PERMIT # NO1047
ON-SITE SEWAGE DISPOSAL PERMIT for: Reb 58 7 81
Property Owner James Mowbray 134-M
Contractor license number

SCP # N 01047 OWNER: Reb CONTRACTOR: Mowbray
 Map 58, Block 7, Parcel 81, Lot

MOUND SPECIFICATIONS SUMMARY & TABLE OF CONTENTS

SAND MOUND PLAN VIEW

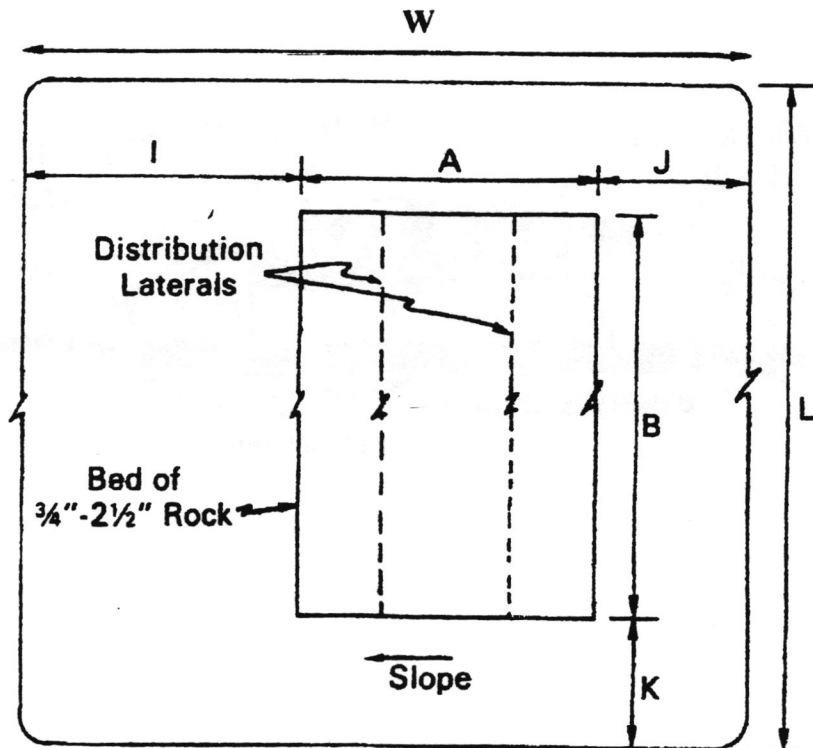
11-27-00 Sand partially in place, stone + pipe in place. Sand is not out to edge of mound. Grass has not been disturbed to free edges of mound

5-24-01 One corner of ~~the~~ mound, during pump test - some surface discharge at turn up.

Grass/vegetation is sparse - extremely dry - must mow by Aug 2001

8/28/01 entire mound covered with weeds - 4'-5' high - called Mrs Reb on 10/24/01 - the mound must be stabilized with veg over winter - she will contact Mowbray

TYPICAL 5' X 5' X 5' PUMP CHAMBER

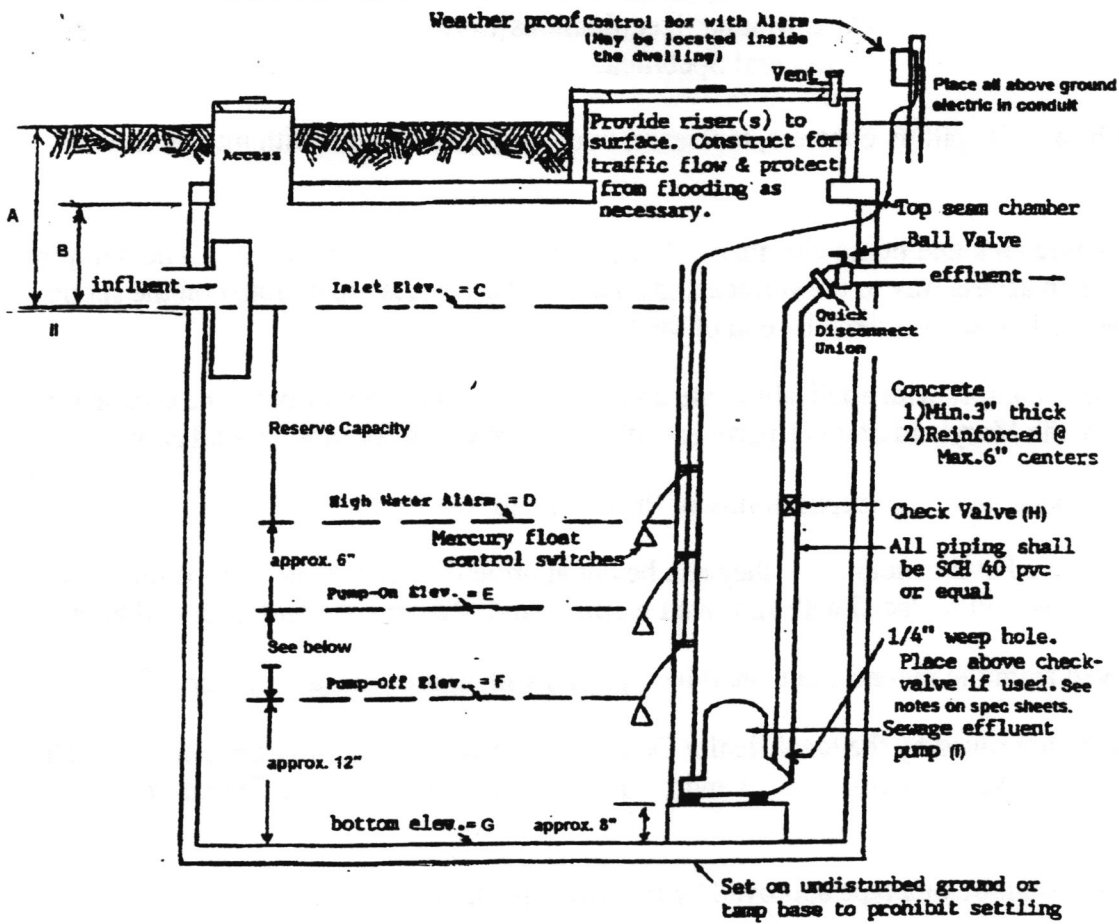
a. Second check valve required in the force main 300 feet from the pump chamber.
